Avolites Ltd.

Engineering Change Notice

Title	A2K tray connector change
ECN Number	ECN-0120
Equipment	ART2000 trays made during early part of 2000 Which have Clear Zink finish instead of non pacifated galvanised finish (gold)
Author	JB Toby
Drawing Number	none
Date	22/05/00

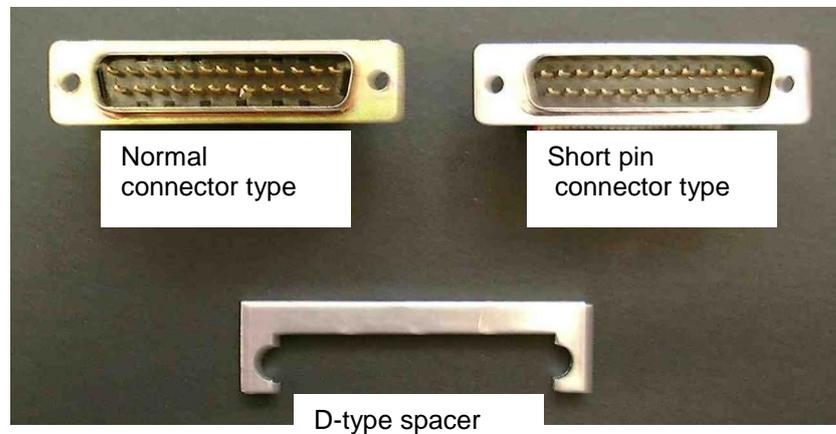
Reason for ECN	Different connector supplied by manufacturer , which has shorter pins
Special Parts required	1322-0050AA D-type spacer
Special Tools required

- Remove M3 screw and nyloc nut on right side of the D-type connector .
- Loosen left side M3 screw and nyloc nut by 2 mm
- Carefully pull the connector of the tray and insert spacer between connector and tray
- Insert right side M3 screw and nyloc nut
- While keeping the connector centred tighten both screws.
- Refit tray in the dimmer and test
- This concludes this ECN
